ED-HMI3630-133C

PCN

by EDA Technology Co., Ltd

1 Product Change Notice 1

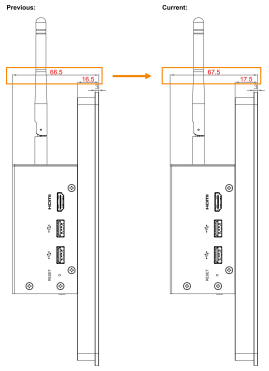
Changes	Results
LCD bezel thickness increased by 1mm	We have optimized the LCD bezel structure to provide additional clearance for internal cable routing. • LCD bezel thickness: adjusted from 16.5mm to 17.5mm. • Total product thickness: correspondingly adjusted from 66.5mm to 67.5mm.
